Re: Indian Point Unit 2
Docket No. 50-247
NL-08-175

Subject: 10 CFR 50.55a Request RR-CRV-75 – Response to Request For Additional Information on Relief from Examinations of Component Welds with Less Than Essentially 100% Examination Coverage for Third-Ten Year Inservice Inspection Interval Closeout (TAC No. MD8416)

**RESPONSE TO REQUEST FOR ADDITIONAL INFORMATION
REGARDING THE THIRD 10-YEAR INSPECTION INTERVAL
REQUEST FOR RELIEF RR-CRV-75**

**Response to Request for Additional Information
Regarding The Third 10-Year Inspection Interval
Request for Relief RR-CRV-75 (TAC MD 8416)**

Figure 1

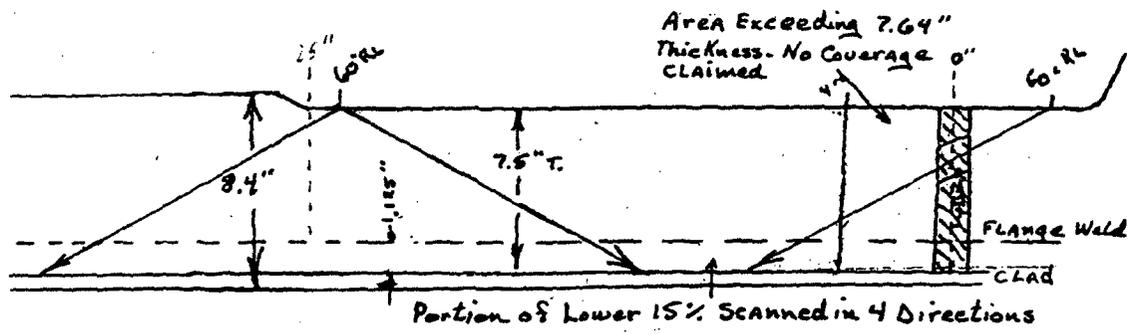
2.1.1 The licensee stated that approximately 85% volumetric coverage could be obtained on reactor pressure vessel (RPV) Upper Closure Head Meridional Welds RVHM-2, -4, and -6 and has provided a general schematic of the RPV upper head depicting in-core instrumentation nozzles and control rod drive mechanisms. The ASME Code states that essentially 100% of the "accessible length" of the subject welds must be examined. The licensee defined the accessible length of the RPV upper closure head meridional welds as approximately 25-inches of the total 57-inches in length.

The accessible 25-inches for each weld is outside the area of control rod drive penetrations and RPV head shroud. However, the licensee's description of the interferences that caused the limited volumetric examinations is not sufficient to demonstrate impracticality, or the descriptions are unclear. The licensee stated:

<100% coverage was achieved when scanned parallel to the weld due to the flange at the bottom of the weld and a taper 25" up on the weld.

The licensee included a rough sketch showing how the blend radius of the flange might impact the parallel scans, however, the "taper 25-inches up on the weld" is not depicted. Please clarify the sketch, or submit a written text, to further describe how both of these geometrical conditions caused the limited volumetric coverage on the subject welds.

2.1.2 The licensee's overall coverage of meridional Welds RVHM-2, -4, and -6 is stated to be 85%, however, other statements of coverage for portions of the weld volumes are provided:

It is unclear why the ASME Code-required orthogonal scans were not performed on the upper 85% of the weld volumes, if it was possible to do so. Please explain this discrepancy.

In addition, it is unclear what is meant by <1% in four directions for the inner 15% weld volume. Since it is expected that degradation, should it occur, may be manifested first in the inner and outer volumes of the welds, it is important to achieve maximum examination coverage for these areas. Please list the extent of volumetric coverage for each of the four scan directions, and adequately describe the cause(s) of limited examinations for each of these scanning directions. Discuss whether alternative angles and/or techniques, such as phased array, were considered to maximize coverage of the inner 15% of the weld volumes.

Approximately 25 inches up on RPV meridional welds RVHM-2, -4, and -6 there is a taper where the RPV upper head goes from a machined surface to a rough as-rolled surface. This taper is around the entire head, not just at the weld locations, and is

located directly below the head shroud. At this point the thickness of the RPV head transitions from approximately 7.5 inches thick to approximately 8.4 inches thick and the head surface becomes very rough. An informational sketch, Figure 1, has been attached and depicts how both the blend radius of the flange and the taper 25 inches up the weld cause the limited coverage on welds RVHM-2, -4, and -6.

An informational sketch, Figure 1, has been attached and depicts how both the blend radius of the flange and the taper 25 inches up the weld cause the limited coverage on welds RVHM-2, -4, and -6. In addition to the informational sketch in Figure 1, for welds RVHM-2, -4, and -6 the following descriptions of weld coverage apply.

1. Approximately 4 inches of the meridional welds adjacent to the flange weld exceeded the Section XI Appendix VIII qualified thickness range and coverage was not credited for this volume. Although coverage for this volume was not credited, the volume was examined and no indications were detected.

2. The accessible length of the meridional welds (approximately 21") was scanned perpendicular to the weld in 2 directions and 100% coverage was achieved. The perpendicular scans would detect flaws parallel to the weld. These perpendicular scans would detect the most likely indications.

3. Due to the flange at the bottom of the weld and the taper 25 inches up the weld the inner 15% was only scanned in three directions. 100% coverage was obtained in the two perpendicular scans and 100% coverage was obtained in one parallel scan. Less than 1% coverage was obtained in the second parallel scan.

4. Using one sided qualified personnel as allowed by PDI (see the first part of this response), >90% of the upper 85% of the weld was covered in one direction perpendicular to the weld and one direction parallel to the weld.

In conclusion, although <1% of the inner 15% was scanned in all 4 directions, 100% of the inner 15% was scanned in three directions (2 perpendicular and 1 parallel) and the perpendicular scans, which are the most critical scans because they detect indications parallel to the weld, achieved 100% coverage. Additionally, the upper 85% of the weld was inspected in one direction perpendicular to the weld and one direction parallel to the weld using one sided qualified personnel as allowed by PDI (see the first part of this response). The inspection of the upper 85% of the weld achieved >90% coverage. The inspections performed and coverage achieved provides high confidence that if degradation was present, it would be detected. Phased Array technology was not considered for use in performing these examinations because this technology was not fully qualified for this application at the time that the examinations were performed.

Figure 2

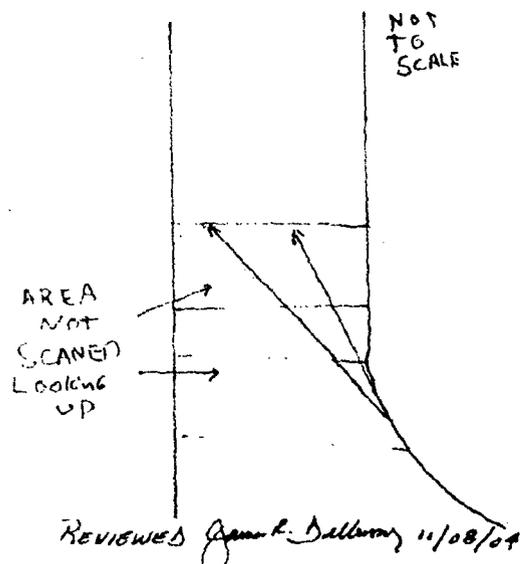
2.1.3 For RPV Closure Head-To-Flange Weld RVHC-2, the licensee submitted sketches depicting the closure head geometry and appurtenances (such as the lifting lugs) that may impact ultrasonic scanning. However, sufficient discussion of scanning limitations has not been included. For each of the techniques applied, describe specifically how the geometric conditions and lifting lugs impacted the volumetric coverage.

It is noted that the licensee was able to dramatically increase coverage through the use of updated equipment, better procedures and ultrasonic techniques during the third interval. Since only limited volumetric sampling is required by ASME Code, it is expected that licensee's will maximize examination coverage throughout the interval using new technology as it becomes available. This expectation is the primary basis for allowing licensee's to wait up to 12 months after the interval is completed to submit requests for relief [10 CFR 50.55a(g)(5(iv))].

The licensee applied better techniques and equipment to only 1/3 of the RPV head-to-flange weld, when in fact, the remaining 2/3 could have been re-inspected with these new techniques and equipment to maximize the coverage for the interval during the same outage without significantly impacting schedule or personnel exposure. Discuss why the new techniques and equipment were not used on the remaining 2/3 of Weld RVHC-2.

Regarding the ultrasonic scans from the flange side, the Westinghouse examination report IP2R16-001, Page 8 of 15, shows a sketch, attached as Figure 2, illustrating the surface contour as well as the scanning angles, and the coverage of those ultrasonic beams. From those sketches with the ultrasonic beam angles included, it can be seen that the ultrasonic beam cannot "reach" any further down into the component because of the sharp transition of the flanged surface.

After reviewing the ultrasonic reports for the 1997 examinations performed by Raytheon and the 2004 examinations performed by Westinghouse, Entergy concluded that both ultrasonic techniques were similar, and the equipment that was used was equivalent. The examinations performed were both conducted to the requirements of ASME Section XI and ASME Section V, Article IV. There were no advanced techniques nor special equipment used in the performance of either examination. The difference in the 50% of coverage that was obtained by Raytheon, and the 84% coverage obtained by Westinghouse are primarily due to differences in coverage calculations. While the Westinghouse examination performed during the 2004 outage attempted an axial scan of the weld from the flange side, it did not significantly increase, compared to the Raytheon examination coverage.

The Raytheon examination coverage was documented as having been 50%. While the report provides no details on how coverage was determined, it was common practice at that time to look at coverage, as being up/down and right/left. The note on Page 2 of 2

of the Limitation Sketch states "no scan of flange side". It would have been common practice to estimate the axial scan from the head side, and the circumferential scans from the head side to constitute that only two of the four examinations were accomplished, equating to 50% coverage. In fact the weld contour was fairly smooth, and the circumferential scans would have covered both the head and flange side of the weld. Since it was not stated nor implied, credit was not taken for that coverage. Westinghouse in turn, seven years later took a different approach to calculate coverage of that same configuration. Westinghouse looked at the Code examination of this area to be made up of nine separate examinations, each one considered equally important. While taking credit for the circumferential scans both from the head and flange side, Westinghouse also took credit for the 0 degree examination; so when they factored in partial coverage for the 45 degree and 60 degree axial examinations from the flange side, the nine examination average brought the total coverage percentage to 84%.

Using the Westinghouse methodology of calculating examination coverage, and back fitting the scans performed by Raytheon during the 1997 inspection and subtracting the limited axial scans Raytheon did not attempt the total percent of coverage would have risen to close to 78%. Although ultrasonic examinations should be conducted in four, EPRI has determined there is a high probability of detection using a single sided ultrasonic examination technique (when necessary) in ferritic materials. Even though the Raytheon examination was performed only from one direction, it was a quality examination, covering the entire examination volume from one direction.

To summarize, the limited 45 degree and 60 degree axial scans performed in 2004 did not significantly impact the overall quality of the examination process, nor significantly increase the actual coverage. Further, these examinations are required to be conducted from the head surface, in a high radiation environment. The slightly improved coverage benefit does not offset the additional radiation exposure that would have been required to perform the examinations a second time.
